CERTIFICATE OF APPROPRIATENESS

Property: 1422 Heights Blvd, Lot 18, Block 157. Houston Heights Subdivision. The property includes a one-story wood frame 2,642 square foot single-family residence and 624 square foot garage situated on a 7,500 square foot interior lot.

Proposal: Alteration- Windows, doors, trim, new gazebo

ELEVATIONS

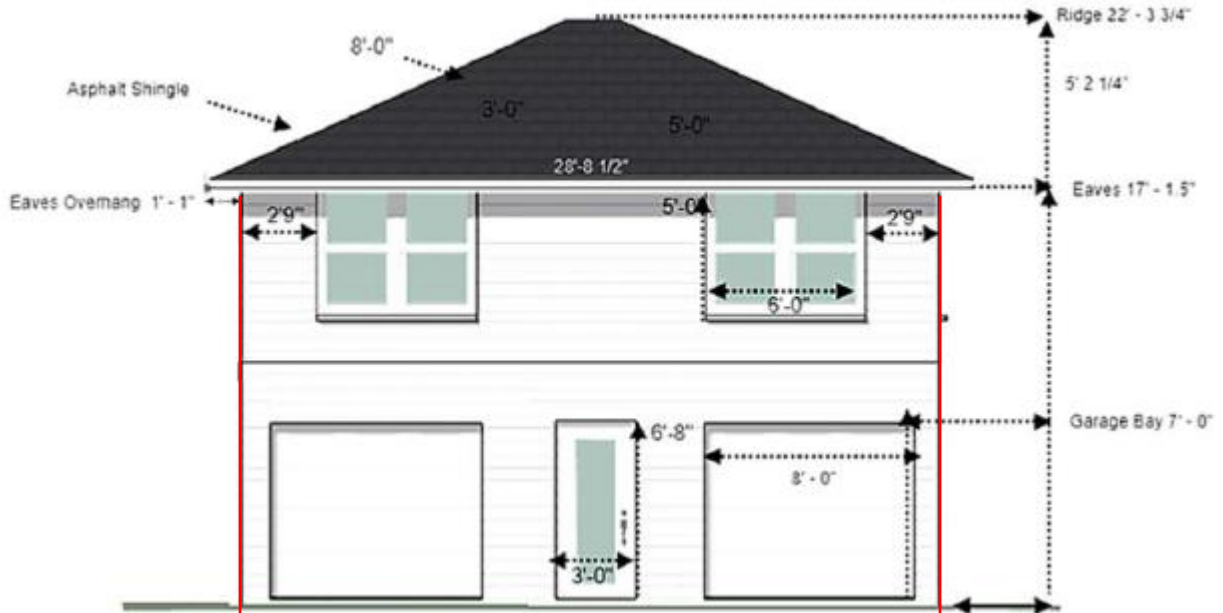
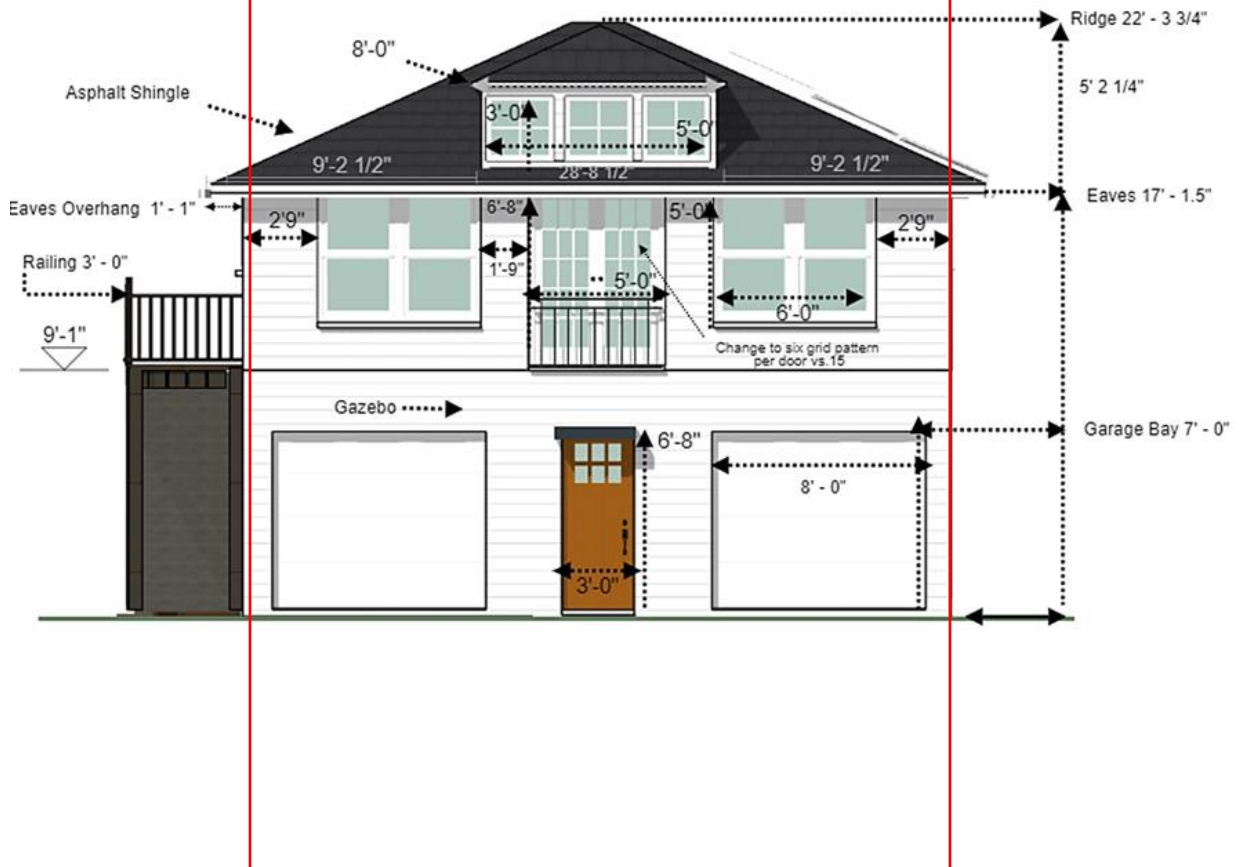
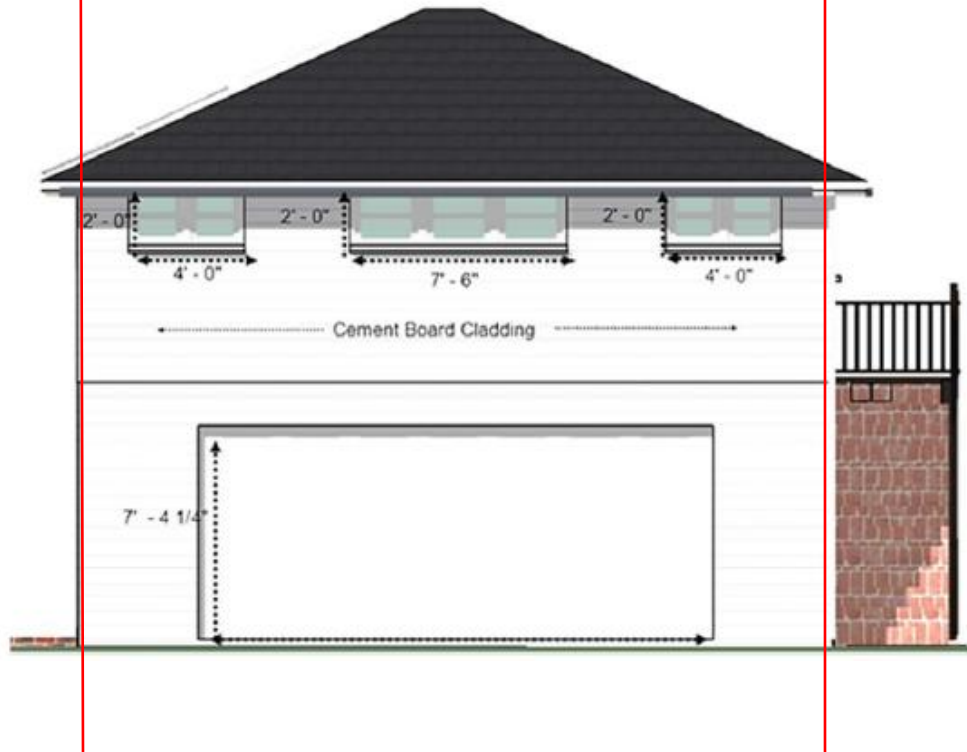
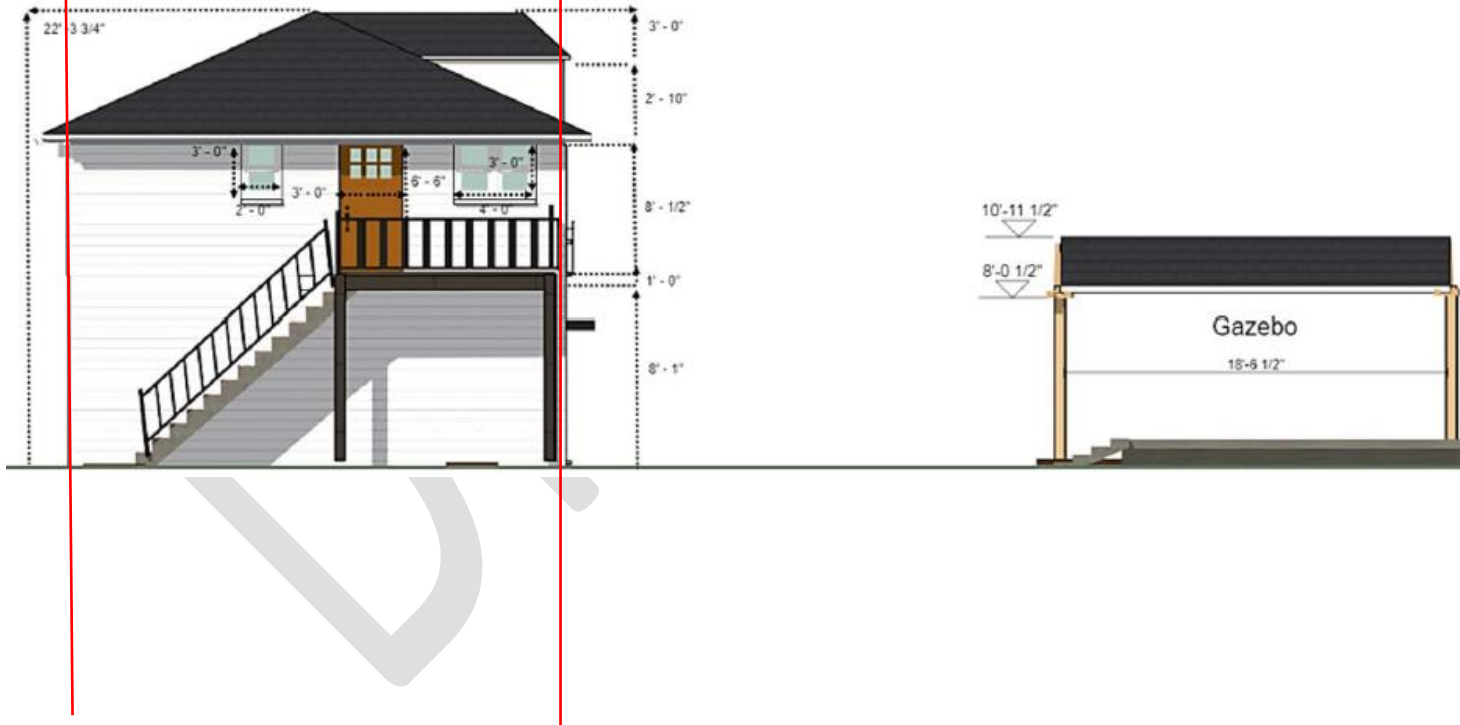
Recommendation: Approval with conditions of no added dormer and no doors between the sets of windows on the second story
